## Agenda

**Planning & Zoning Commission**  
Thursday, April 14, 2022

**STAFF REPORT  
PLANNING AND ZONING COMMISSION  
APRIL 14, 2022**

## Sign Plans: New Sign Cabinet w/ LED Pricer on existing foundation

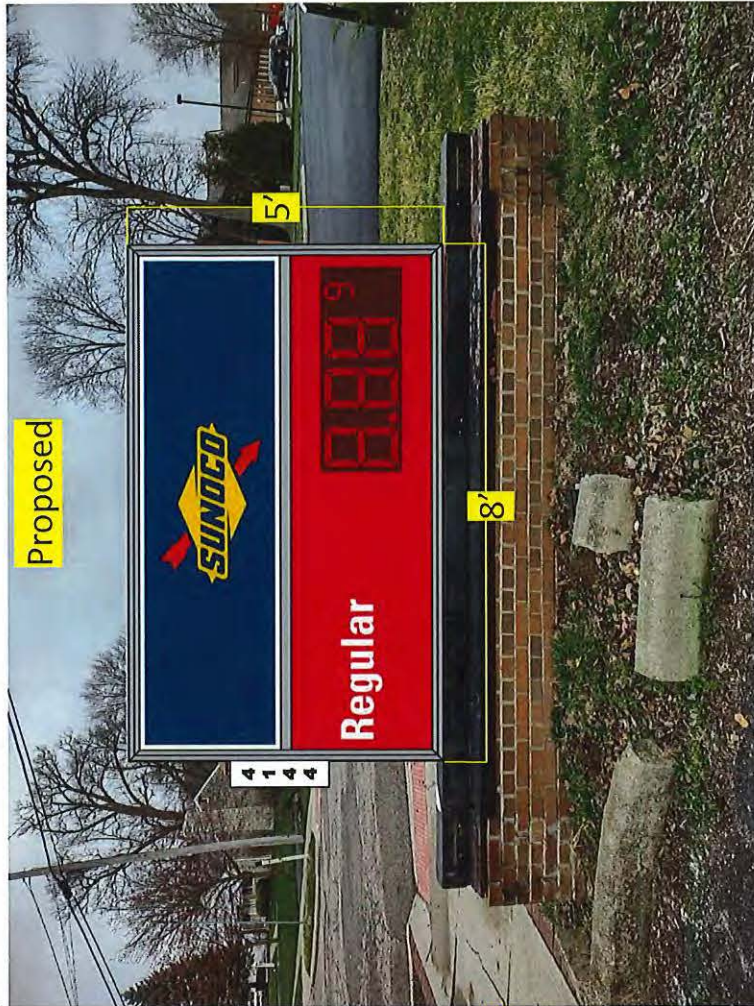
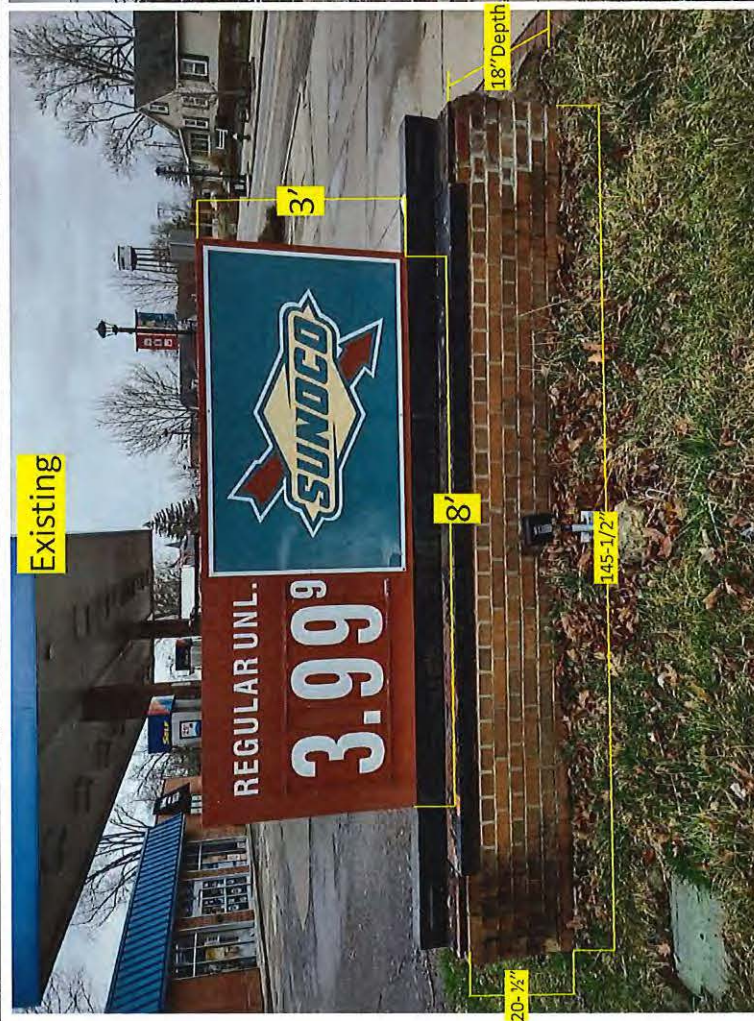
Staff finds that the proposal is generally consistent with the intent of the Sign Code. The proposed sign will be compatible with the character of the general vicinity. Staff recommends approval of the proposed sign with the following six conditions:

- 1) That only the pricer digits are to be internally-illuminated;
- 2) That plans be revised to demonstrate conformance to the provisions of the Sign Code concerning landscaping and light screening along the back and sides;
- 3) That the required landscaping and light screening is installed within 90 days after installation;
- 4) That the masonry base be cleaned as part of the project;
- 5) That no product advertisements are to be displayed on the sign; and

6) That a sign permit be obtained prior to installation.

CITY OF HILLIARD, FRANKLIN COUNTY, OHIO  
FOR  
SITE CONSTRUCTION PLAN  
**VERENA AT HILLIARD COTTAGES**  
**4522 HICKORY CHASE WAY**  
OVERALL SITE DIMENSION PLAN

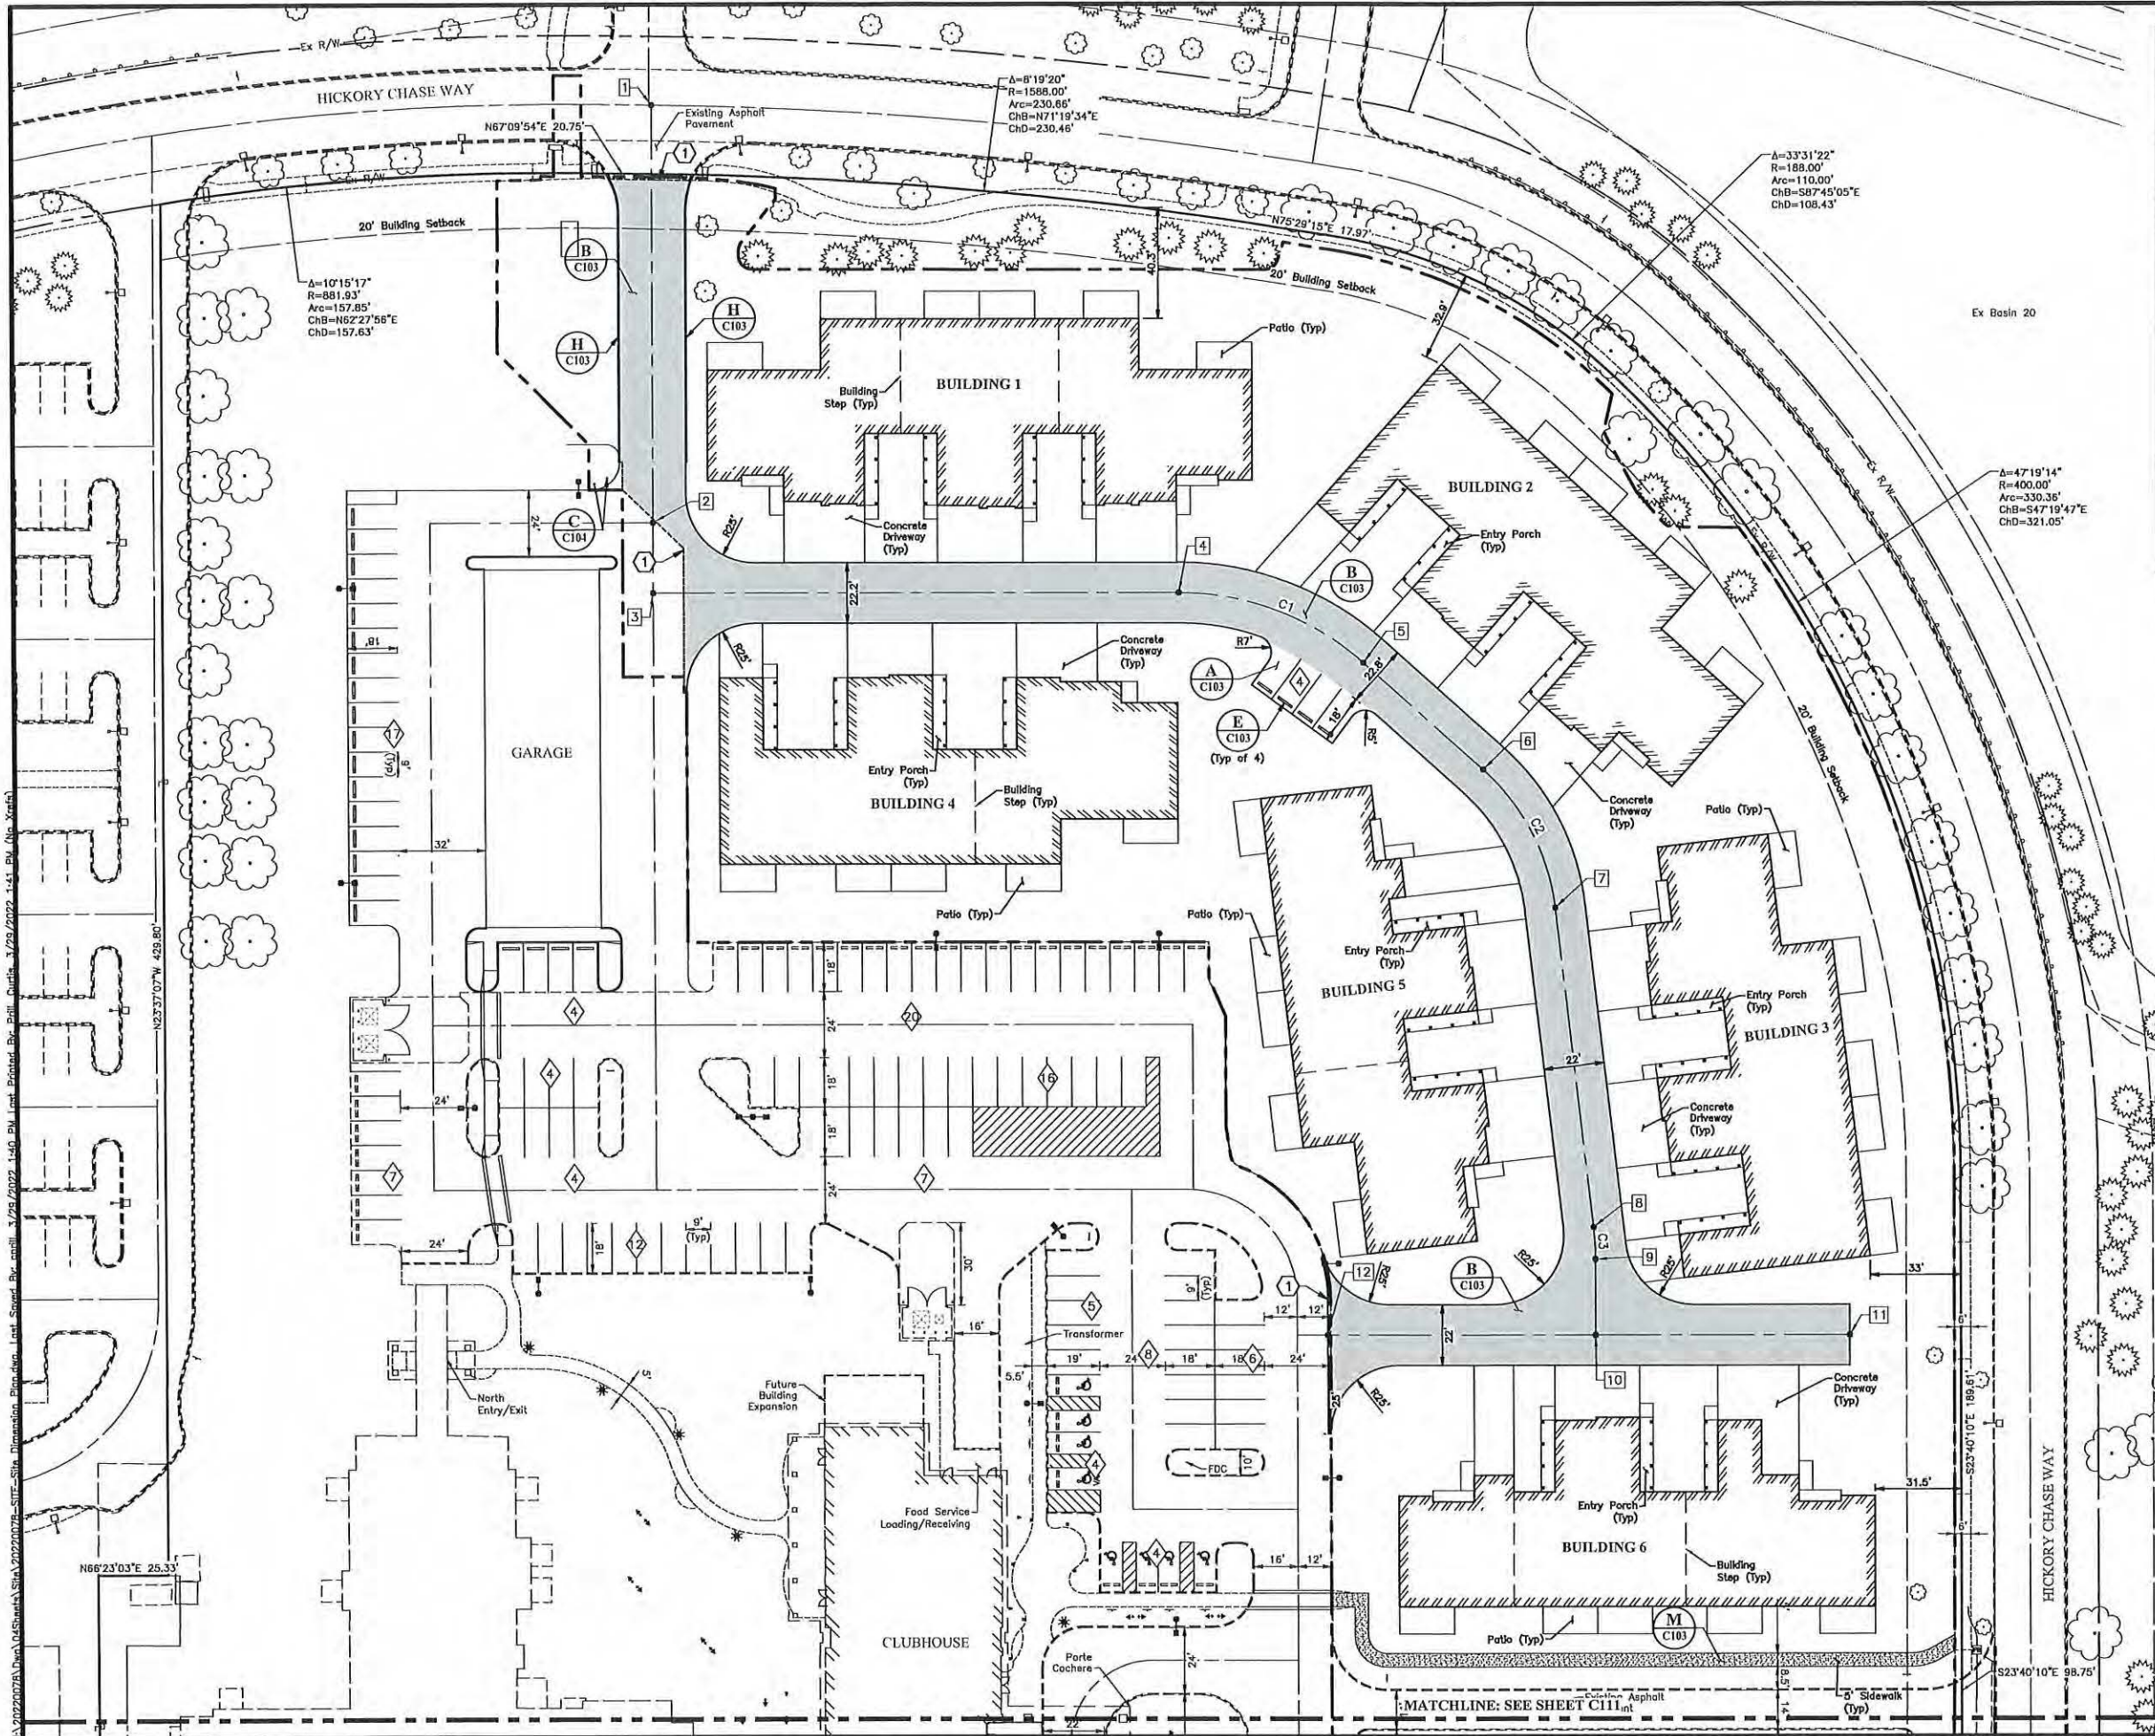
Staff finds that the proposal can be a harmonious part of the Ansmil PUD. Staff finds that the proposal, as revised per the staff comments below, will be generally consistent with the provisions of Hilliard Code Section 1117.08 and the intent of the Ansmil PUD Zoning Development Plan and Text. Based on these findings, staff recommends that proposed modification of the Ansmil PUD Concept Plan and Development Text be approved with the following 5 conditions:

- 1) That the proposed text is revised to specify that the minimum setback from property lines other than those along a public right-of-way must be not less than 10 feet for decks and not less than 3 feet for patios;
- 2) That the proposed PUD text modifications are reconciled to match the proposed representative building elevations, subject to staff approval, prior to being scheduled on a Council agenda;
- 3) That details for any proposed fencing are provided for Planning and Zoning Commission review;

- 4) That the proposed text is revised to specify that the proposed modifications are limited to the subject property and not the entire Subarea E1; and
- 5) That the proposed PUD Zoning Development Plan and Text are revised consistent with the staff recommendations listed below in the staff report prior to the case being scheduled on a Council agenda.

Drawing Name:  
ELEVATIONS

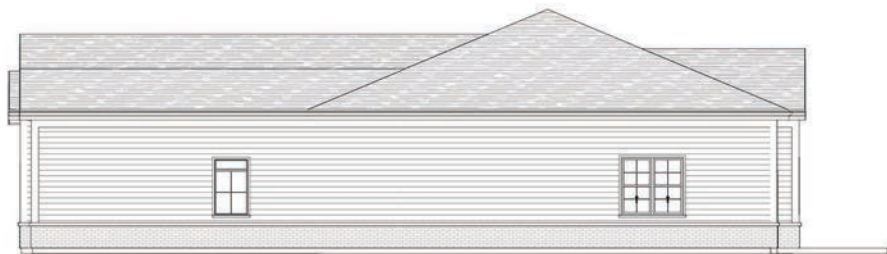
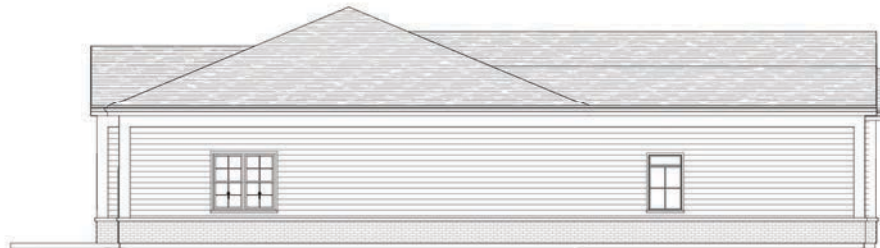
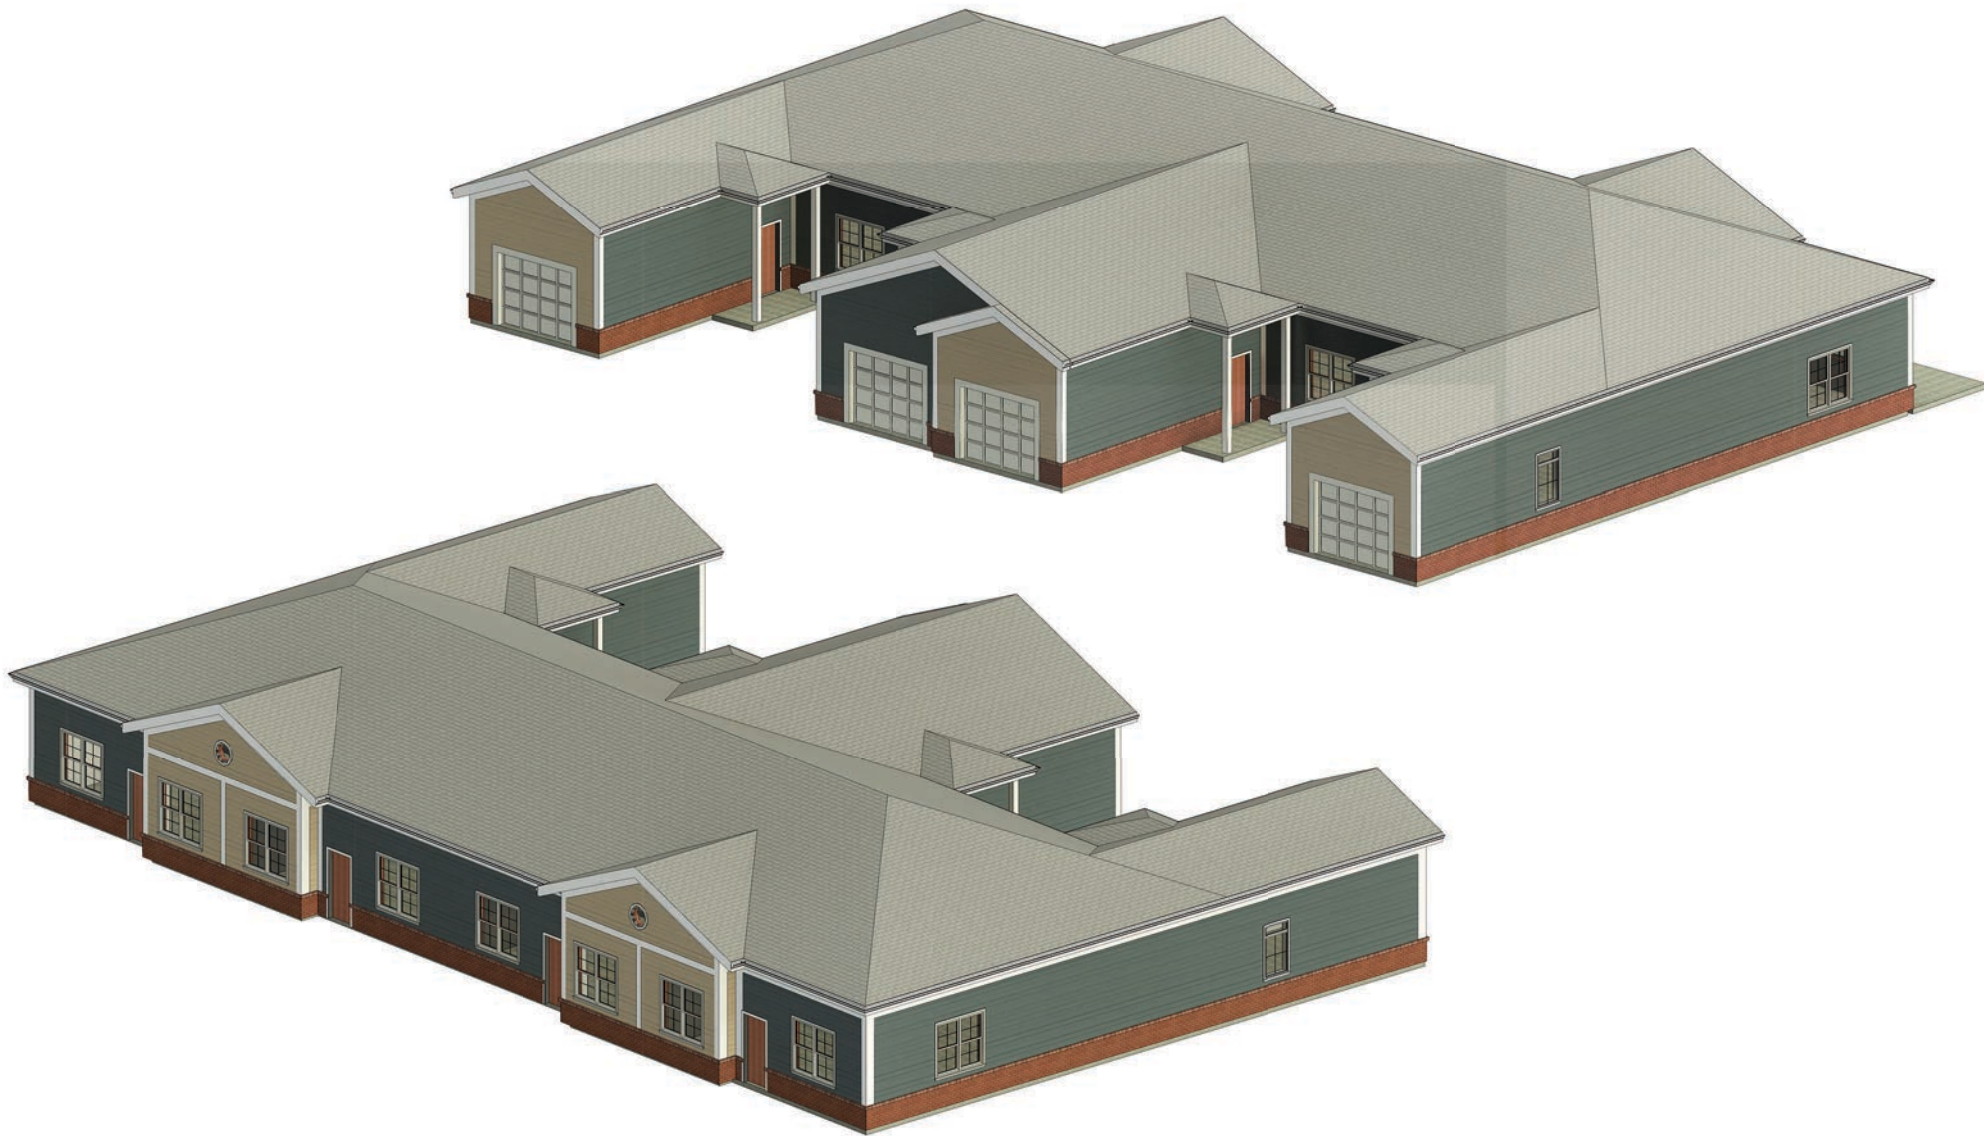
- The proposed building elevations are for Building A which is representative of the architecture of the multiple building types shown on the site plan. The buildings have one story with gables on the front and rear of the building and hip roofs on the sides. The rear elevations (some of which will face Hickory Chase Way) demonstrate a similar level of architectural design as the front. A red brick wainscot is shown on all sides, with horizontal siding in two colors (gray and tan), and gray asphalt shingles. Side elevations have multiple windows. **[Staff finds that the proposed building elevations do not meet the minimum percentage of brick/stone required per the text; however, staff finds that the proposed building elevations are consistent with the requirement to have four-sided architecture. Staff recommends that the proposed PUD text modifications are reconciled to match the proposed representative building elevations prior to being scheduled on a Council agenda.]**
